UNITED STATES PATENT AND TRADEMARK OFFICE

APPLICATION NO.	FILING DATE	FIRST NAMED INVENTOR	ATTORNEY DOCKET NO.	CONFIRMATION NO.
10/790,524	03/01/2004	Douglas P. Gethmann	06005/39970	2733

Office Action Summary	Application No. 10/790,524	Applicant(s) GETHMANN, DOUGLAS P.	
	Examiner Ernesto Garcia	Art Unit 3679

DETAILED ACTION

Martus, 1,753,154

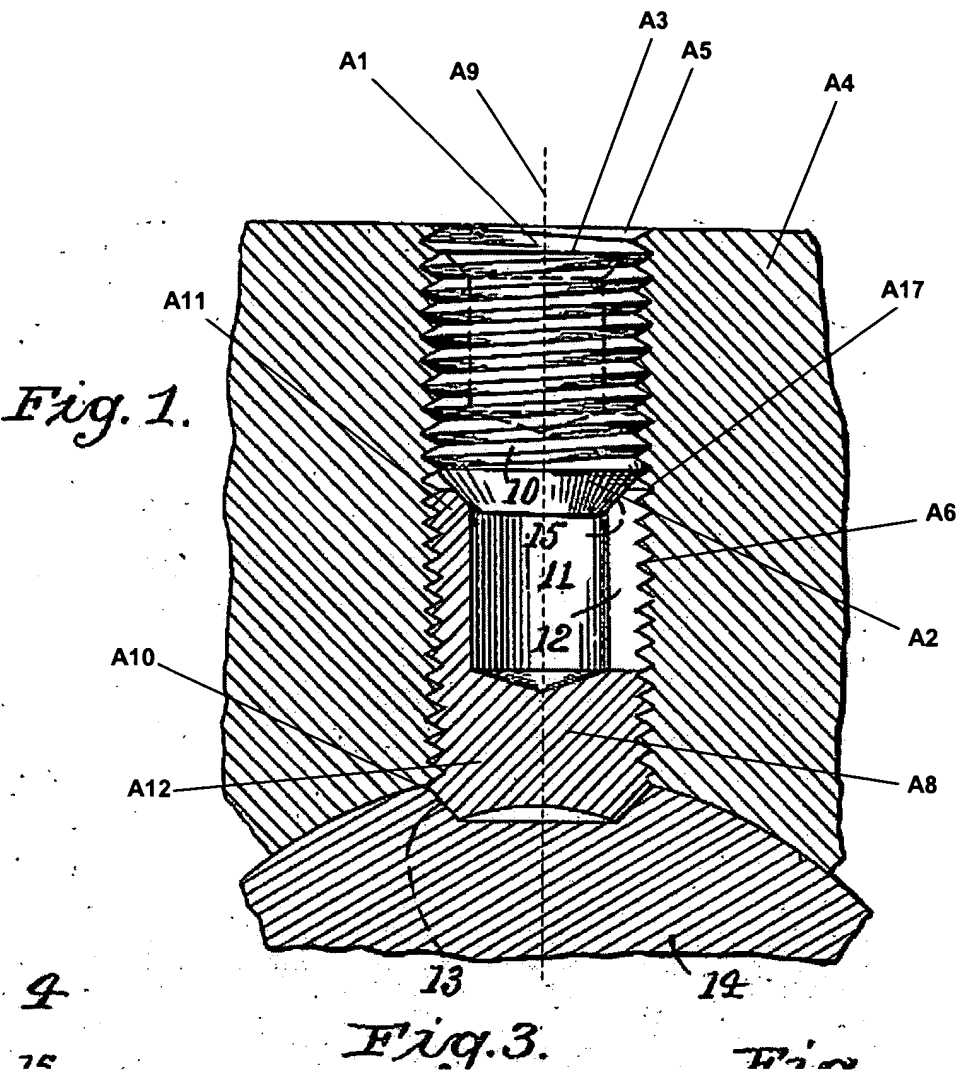
Claims 1-7 and 9-15 are rejected under 35 U.S.C. 102(b) as being anticipated by Martus, 1,753,154 (see marked-up attachment).

Regarding claim 1, Martus discloses, in Figure 1, a locking mechanism comprising a body **A8** and a wedge **A13**. The body **A8** extends along an axis **A9** and has a non-threaded outer side surface **A10**. The body **A8** defines a first axial end **A11** and a second axial end **A12**. The wedge **A13** projects from the first axial end **A11** of the body **A8**. The wedge **A13** has an inner engagement surface **15** and an outer engagement surface **A17**. The wedge **A13** is sufficiently pliant.

Regarding claim 2, the wedge **A13** forms a continuous rim extending around the first axial end **A11** of the body **A8**. The rim has a triangular cross-section.

Regarding claim 9, Martus discloses, in Figure 1, a locking assembly comprising a first connection member **A1**, a second connection member **A4**, and a locking mechanism **10**. The first connection member **A1** defines an insertion end **A2** formed with male thread **A3**. The second connection member **A4** defines an aperture **A5** formed with female thread **A6** complementary to the male thread **A3**. The locking mechanism comprises a body **A8** and a wedge **A13**. The body **A8** extends along an axis **A9** and has an outer side surface **A10** sized. The body **A8** defines a first axial end **A11** and a second axial end **A12**. The wedge **A13** projects from the first axial end **A11** of the body **A8**. The wedge **A13** has an inner engagement surface **15** and a substantially smooth outer engagement surface **A17**. The wedge **A13** is sufficiently pliant.

With respect to Martus, applicant has the end A11 does not face outwardly and the surface A17 is not positioned "engage the threaded aperture of the female member". In response, this is not persuasive. According to Martus, end A11 has a face and therefore, the end A11 will face outwardly. Further, it is clear that the surface A17 will engage the threaded aperture of the female member because there is a thread connection at the interface. Applicant further argues that Martus cannot support a *prima facie* case of obviousness. In response, applicant should note that the rejections based on Martus are not made under an obviousness rejection but rather anticipation under 35 U.S.C 102.

Stitt, 3,352,343

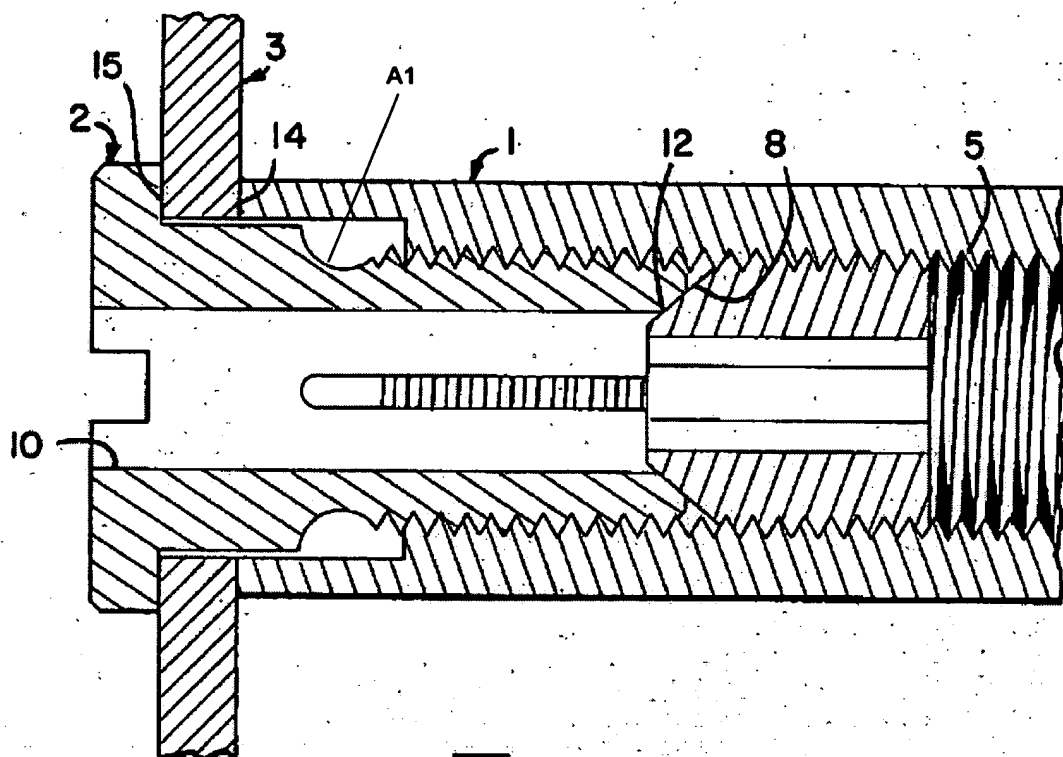
Claims 18-23 are rejected under 35 U.S.C. 102(b) as being anticipated by Stitt, 3,352,343 (see marked-up attachment).

Regarding claim 23, Stitt discloses, in Figure 2, a locking mechanism comprising a valve actuator rod **1**, an extension stem **6**, and a generally cylindrical body **2**. The rod **1** has a threaded aperture **5**. The stem **6** has a tip **8**. The body **2** has a second end **16** and a first end (near **8**). The second end **16** faces into the aperture and the first end faces out of the aperture **5**. The first end of the body **2** forms a deflectable wedge with a triangular cross-section. The wedge has a generally conical inner engagement surface **12** and a non-thread outer engagement surface **A1**.

Therefore, the inner engagement surface can be adapted to engage the tip of the extension stem and the non-threaded outer engagement surface can be adapter to engage the threaded aperture of the rod. Further, the deflectable wedge can outwardly deflect against the threaded aperture in response to an insertion force.
